**RESPONSE TO SUBMISSIONS - SSD 5249 MOD 3**  
**1 LAWSON SQUARE, REDFERN**

We write on behalf of Lawson Square Pty Ltd in response to the Department of Planning and Environment's (DPE) Response to Submissions letter, dated 12 May 2017. The purpose of this letter is to respond to the matters raised by the DPE, namely:

**Figure 1** – Proposed aluminium louvres on the Tower 2 western façade  
Source: Candalepas Associates

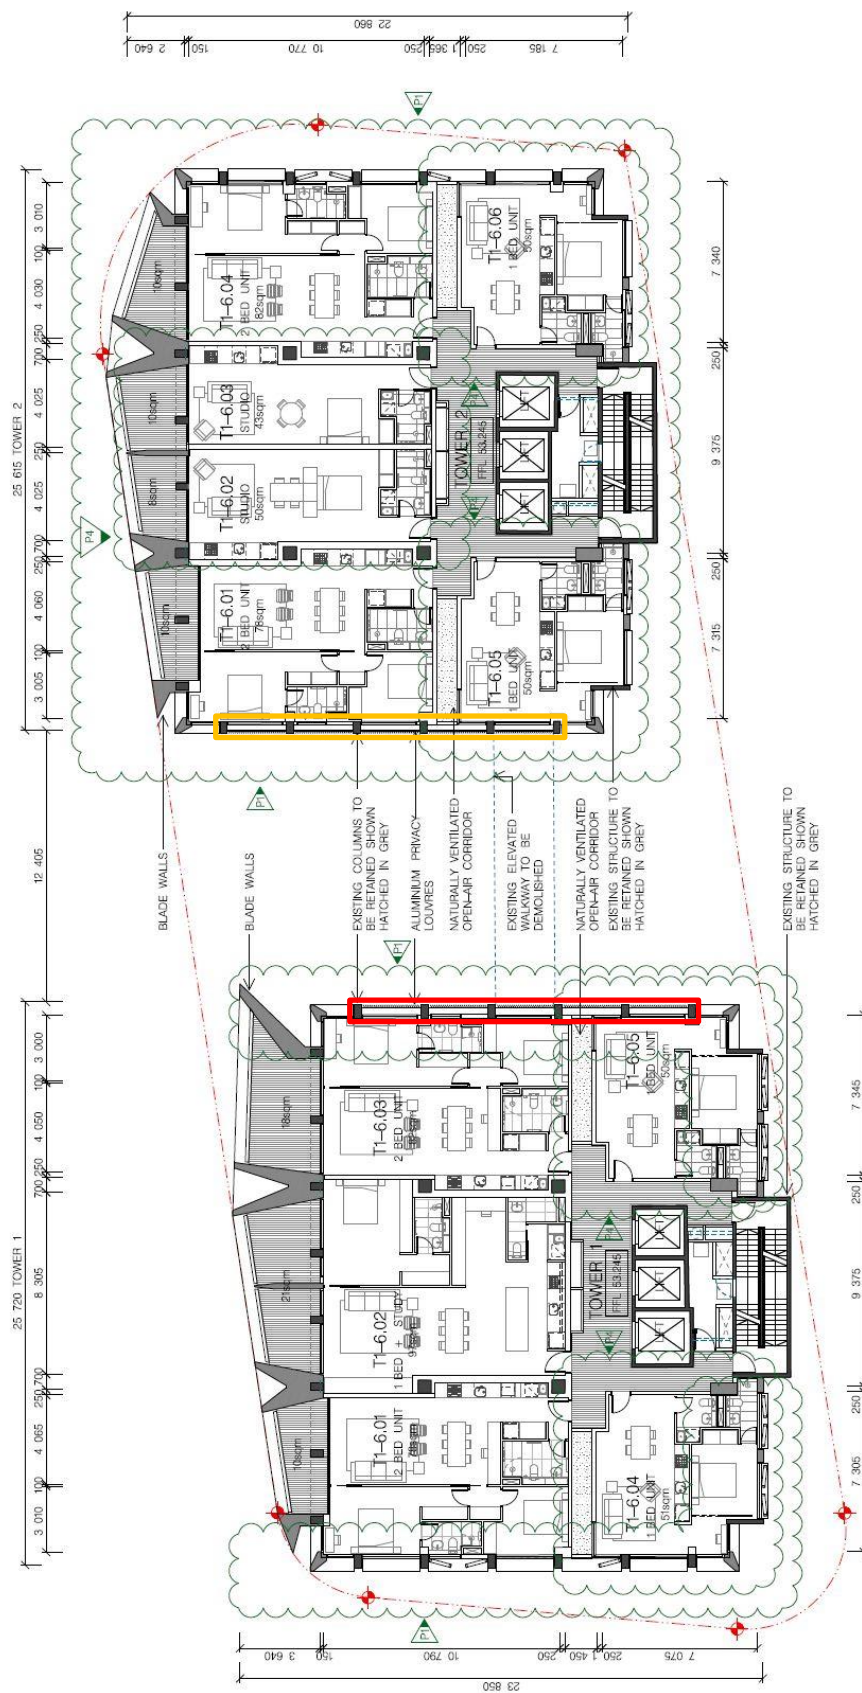
*"that further consideration is given to how the proposed changes to the façade treatment maintains adequate privacy between apartments within the site and those to the south of the site."*

The eastern façade of Tower 1 and the western façade of Tower 2 are proposed to accommodate fixed aluminium louvres. The louvres are angled to prevent overlooking, enable light to enter the apartments and allow occupants to enjoy views to the north. **Figures 1 and 2** illustrate the proposed aluminium louvres. The louvres are drawn on the plans submitted with MOD 3.
